PROJECT: WSISD - New Maintenance and Operations Warehouse 24-103.00      DATE: 5/30/2025

SUBJECT: 24-103.00 - New Maintenance and Operations Warehouse - Addendum 01      TRANSMITTAL ID: 00006

ADDENDU NO. 1 TO THE DRAWING  
FOR  
**NEW MAINTENANCE AND OPERATIONS WAREHOUSE**  
**WHITE SETTLEMENT ISD**  
**WHITE SETTLEMENT, TEXAS**

**SHEET NO.**  
A2.21

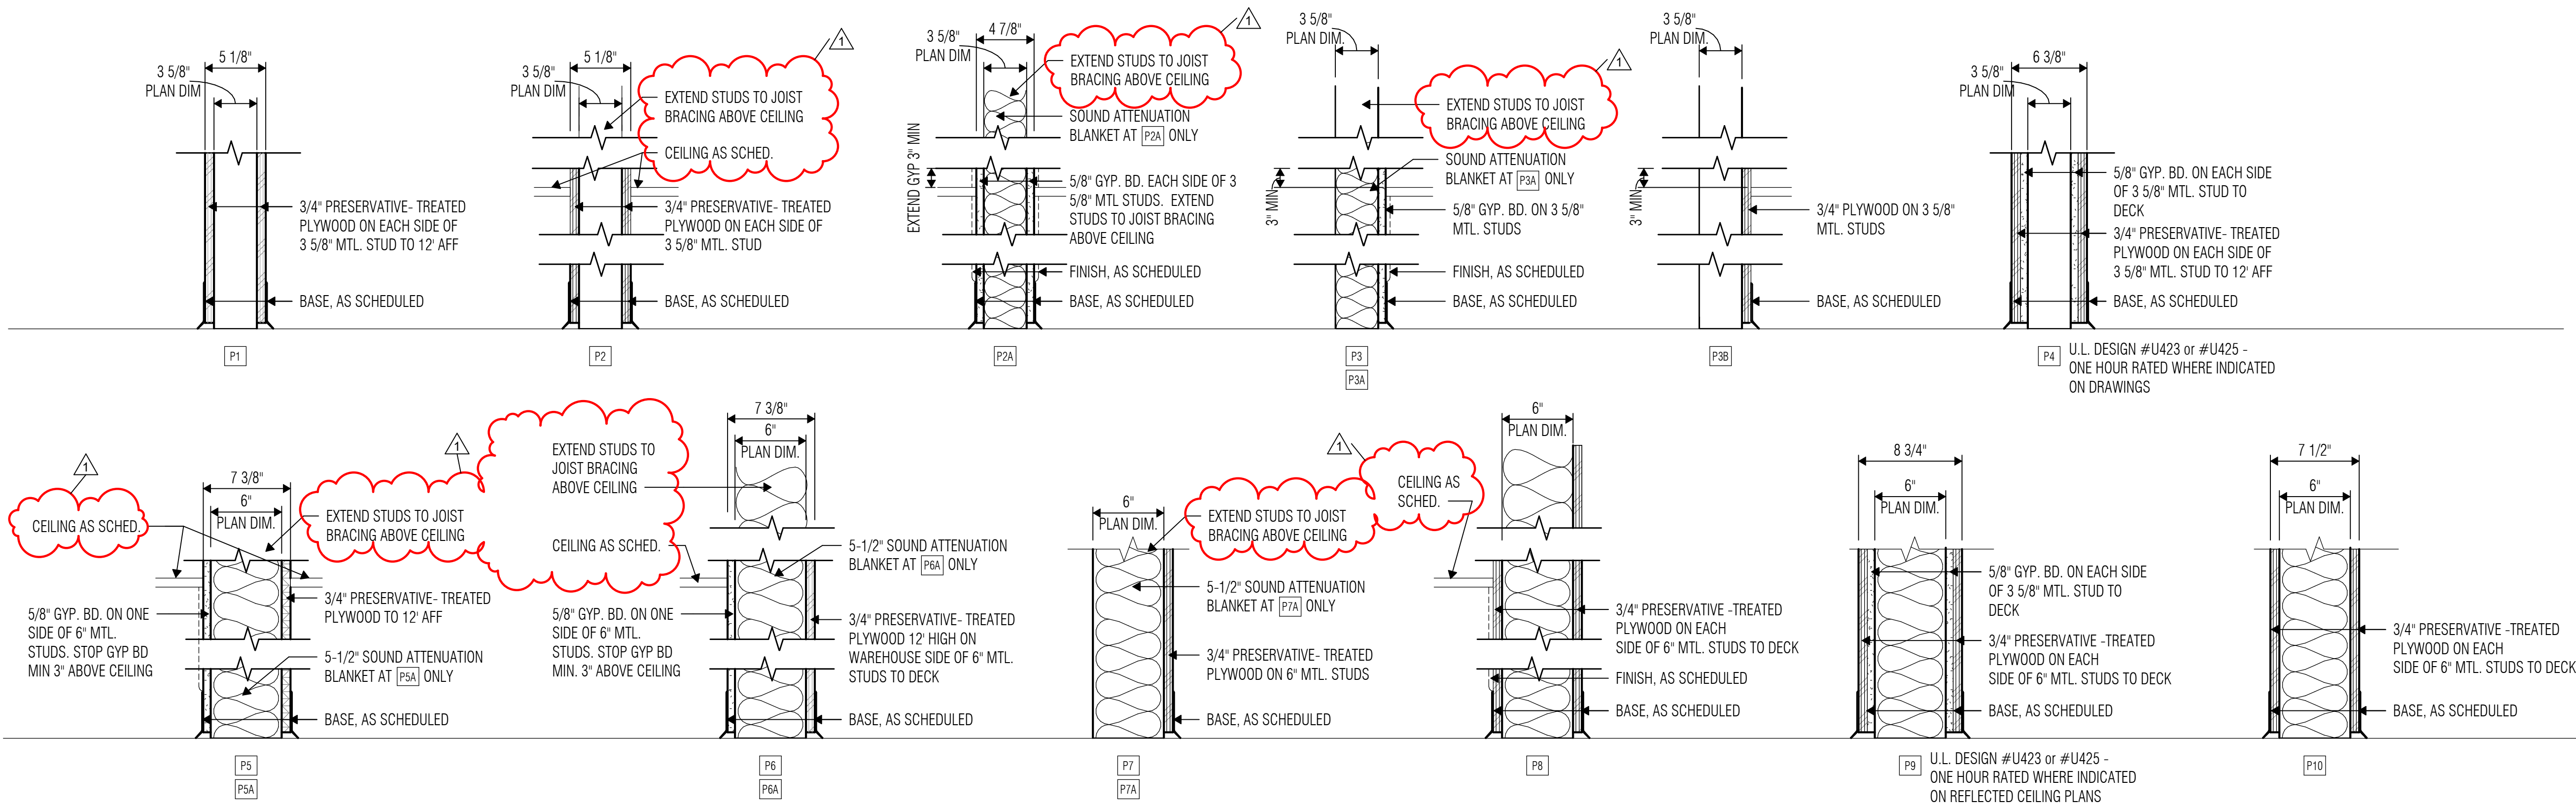
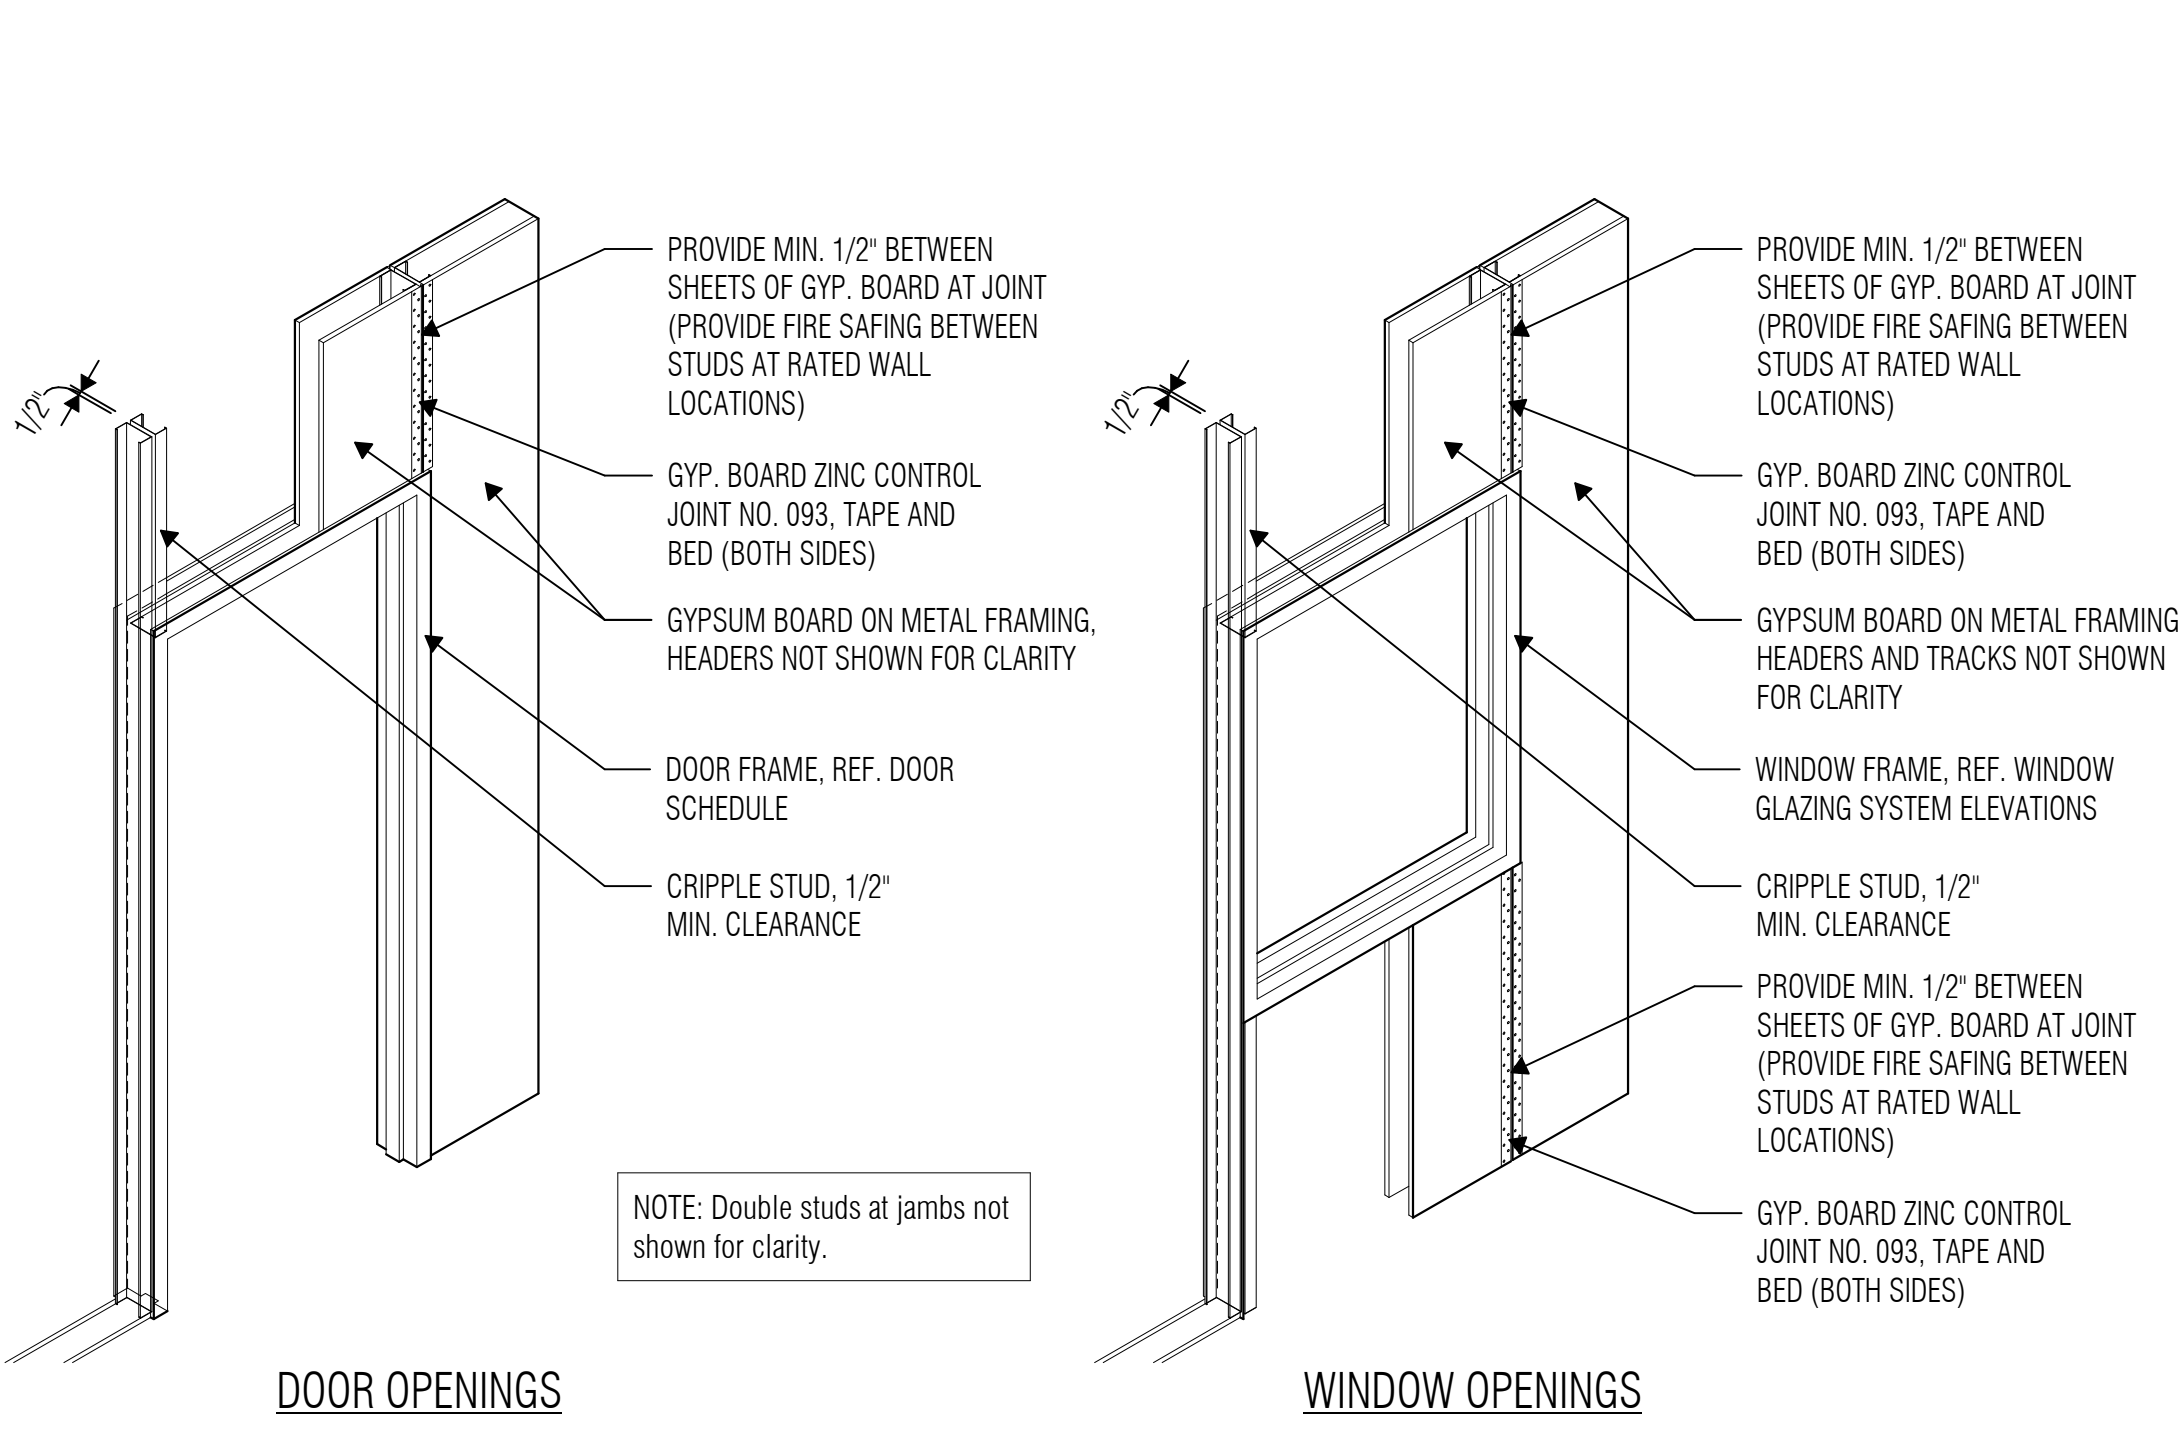
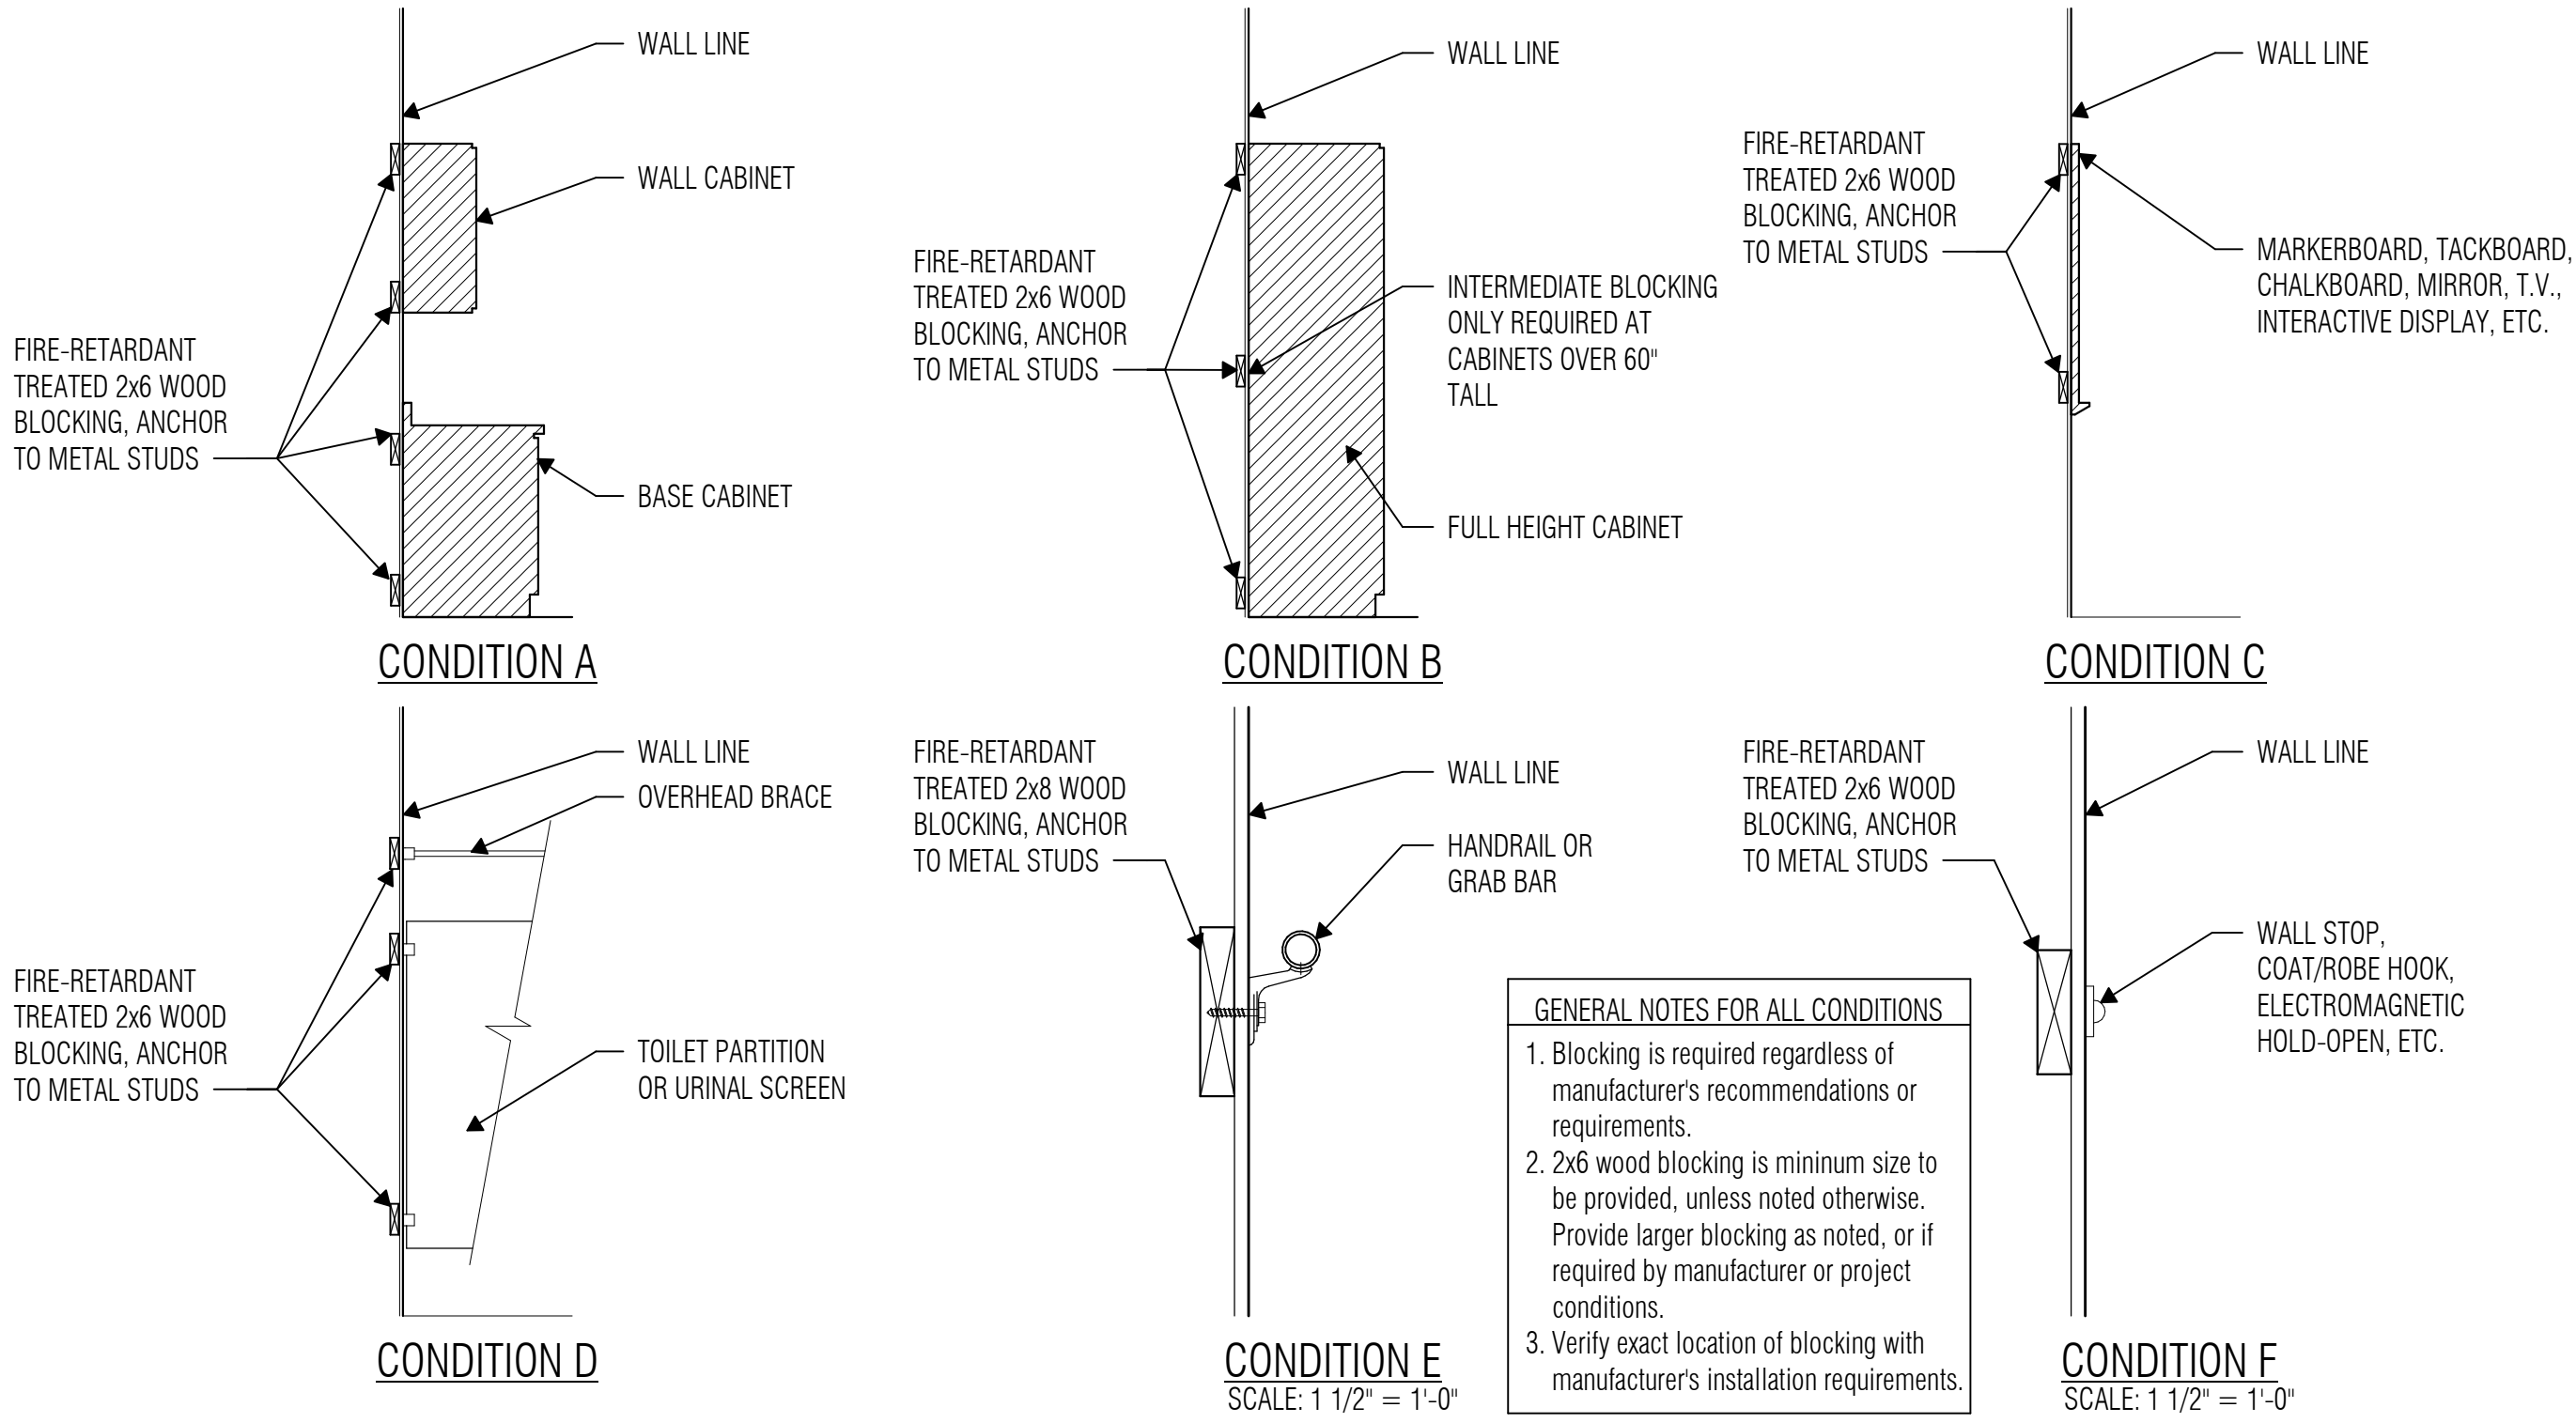
**1.4 SHEET A2.21 PARTITION TYPES**

- A. Note "Extend studs to joist bracing above ceiling" and "Ceiling as sched." added to Partition wall P2.
- B. Note "Extend studs to joist bracing above ceiling" added to Partition wall P2A.
- C. Note "Extend studs to joist bracing above ceiling" added to Partition wall P3/P3A.
- D. Note "Extend studs to joist bracing above ceiling" added to Partition wall P5/P5A.
- E. Note "Extend studs to joist bracing above ceiling" and "Ceiling as sched." added to Partition wall P6/P6A.
- F. Note "Extend studs to joist bracing above ceiling" added to Partition wall P7/P7A.
- G. Note "Ceiling as sched." added to Partition wall P8.
- H. On Partition Notes, notes referencing CMU have been removed as it does not apply to project.
